Marshfield Police Department Needs

Re: MARSHFIELD POLICE STATION EXISTING CONDITIONS ANALYSIS,
NEEDS ASSESSMENT AND LONG TERM MASTER PLANS

Needs Assessment for the Marshfield Police Station

ARCHITECT POWERS & COMPANY INC 100 STATE STREET SUITE 200 BOSTON, MA 02109 TELEPHONE: 617-451-0797 FACSIMILE: 617-451-0798 CONSULTANT	CLIENT THE TOWN OF MARSHFIELD PROJECT ACCESSIBILITY IMPROVEMENTS MARSHFIELD POLICE STATION 100 STATE STREET MARSHFIELD, MASSACHUSETTS	SCOPE OF WORK WITH EXISTING PLAN	DATE: 5 MAR 1998 SCALE: 1/8"=1'-0" PAGE REVISIONS	SHEET NO
--	---	--	--	----------

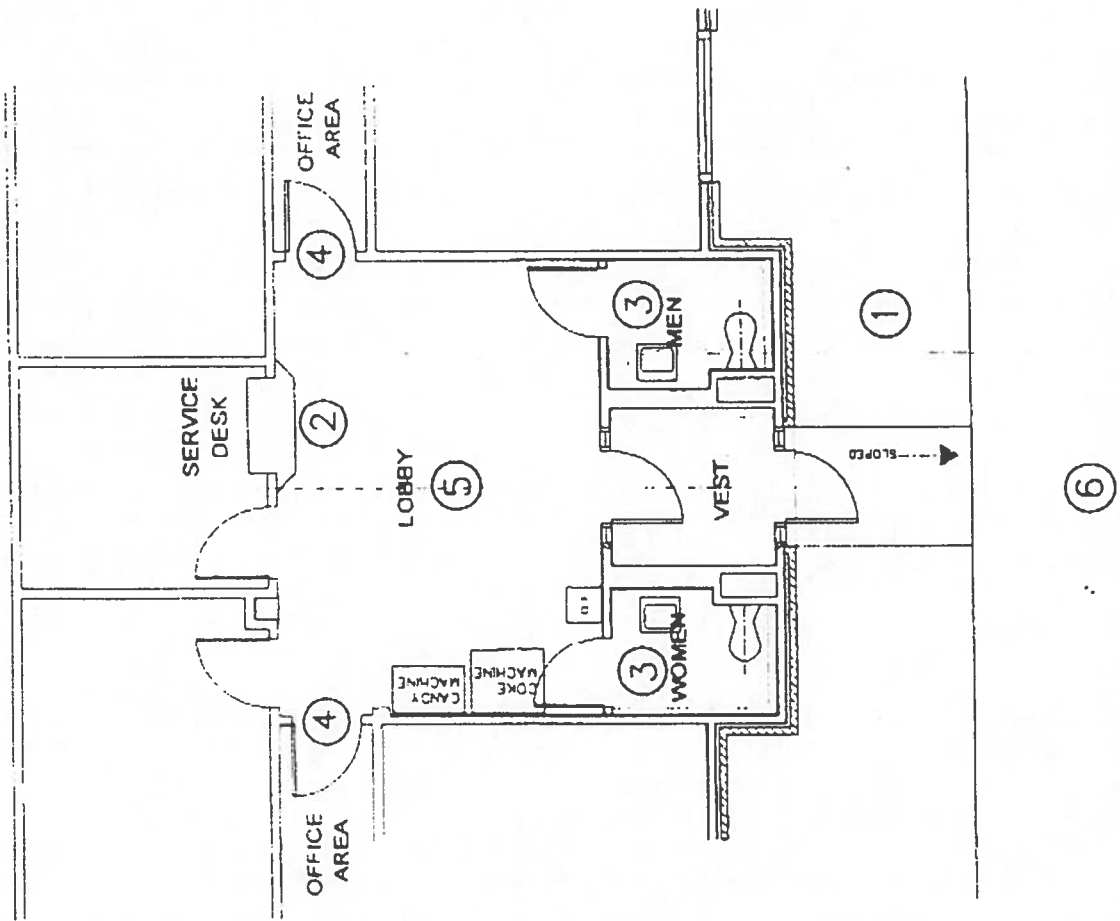
- ① PROVIDE ADA COMPLIANT PRIMARY ENTRY TO RAMP WITH LIGHTING FOR DISABLED AND STAIRS FOR ABLE-BODIED
 - 1a NEW FRONT DOOR WITH HC CLOSURE
 - 1c MECHANICAL DOOR OPERATOR
 - 1d SIGNAGE WITH BRAILLE
 - 1e MOVE HC PARKING TO LOCATION DIRECTLY RELATED TO RAMP ACCESS

- ② PROVIDE ADA COMPLIANT LOBBY SERVICE DESK
 - 2c HC LEVEL DESK
 - 2e IMPROVED VISUAL CONNECTION FOR SIGHT IMPAIRED
 - 2c IMPROVED VOICE TRANSMISSION FOR HEARING IMPAIRED

- ③ PROVIDE ADA COMPLIANT MALE AND FEMALE LAVATORIES
 - 3a. EXPAND EXISTING LAVATORIES
 - 3b. PROVIDE NEW FINISH AND LIGHTING AND ADA COMPLIANT FIXTURES

- ④ PROVIDE NEW ADA COMPLIANT OFFICE AREA ENTRY DOORS (PROVIDE ADA REQUIREMENT FOR 18" CLEARANCE ON PULLSIDE OF DOOR AND RESOLVE DOOR SWINGS)

- ⑤ PROVIDE LOBBY REFURBISHING
 - 5a. ALL NEW FINISHES:
 - FLOORING
 - CEILING
 - LIGHTING
 - SIGNAGE
 - 5b. REMOVAL OF INTERIOR VESTIBULE DOOR
 - 5c. NEW OUTLETS AS REQUIRED
 - 5d. NEW HEATING FIXTURES AS REQUIRED DUE TO EXPANDED LAVATORIES
 - 5e. NEW ADA COMPLIANT WRITING TABLE AND EXHIBIT PANEL

- ⑥ PROVIDE EXTERIOR IMPROVEMENTS
 - 6a. SIGNAGE AT STREET
 - 6b. SIGNAGE AT BUILDING
 - 6c. LIGHTING AT PARKING
 - 6d. SIGNAGE AND STREET CURB CUTS
 - 6d. LANDSCAPING
